ANN ARBOR HISTORIC DISTRICT COMMISSION

Staff Report

ADDRESS: 919 West Washington Street Application Number HDC25-0031

REPORT DATE: March 13, 2025

2nd FLR PROPOSED PLAN 1 SCALE: 1/8" = 1'-0"

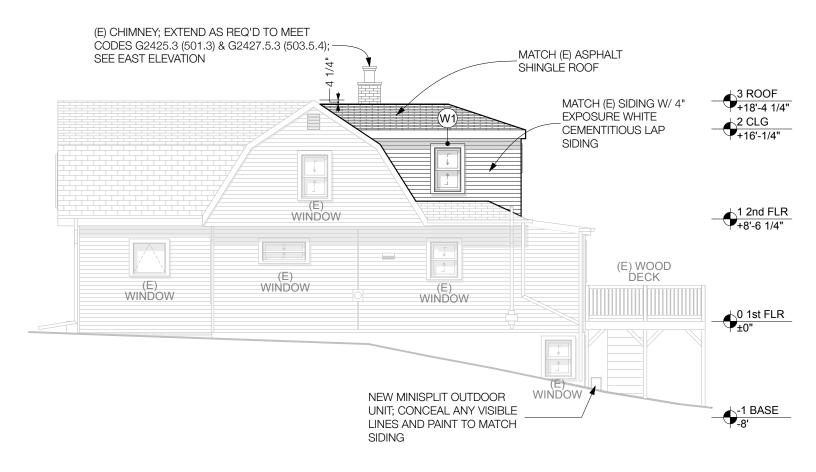
- 2. The addition would add 114 square feet of floor area. The applicant is recalculating the pre-1945 and current floor areas so the sum of post-1944 additions can be turned into a percentage. Based on Sanborn maps and the current roof plan, staff is confident that the proposal will still be well within the *Design Guidelines* maximum of 50%. There is no change to the current footprint of the house.

PROPOSED WEST ELEVATION (SIDE)
SCALE: 1/8" = 1'-0"

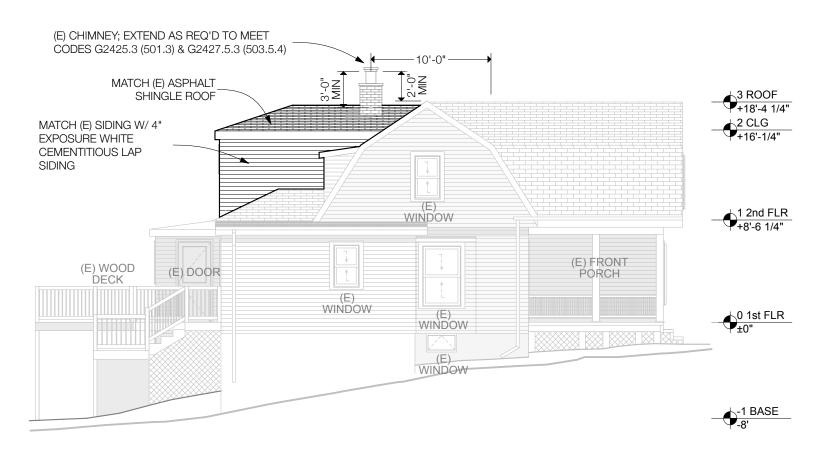
- 1. Addition. The addition sits on top of the original single-story rear wing of the house. It is set in 21" from the southwest corner of the house, and several feet from the southeast corner. A wall dormer with a single awning window on the rear-facing roof is probably not from the period of significance. The awning window would be removed and infilled, and part of the wall dormer would be engulfed in the new addition. Cladding is 4" cementitious lap with an asphalt roof to match the existing. One new double hung window on the west side and one new awning window on the rear of the addition are Andersen 400 series vinyl clad wood. The hip roof of the addition ties into the existing roof 4 1/4" below the ridge. Enough of the current roof will remain visible that one could figure out a good approximation of the original configuration of the rear wing. The metal vent stack in the existing brick chimney would be extended to be 3' above the new roof, to meet building code requirements.
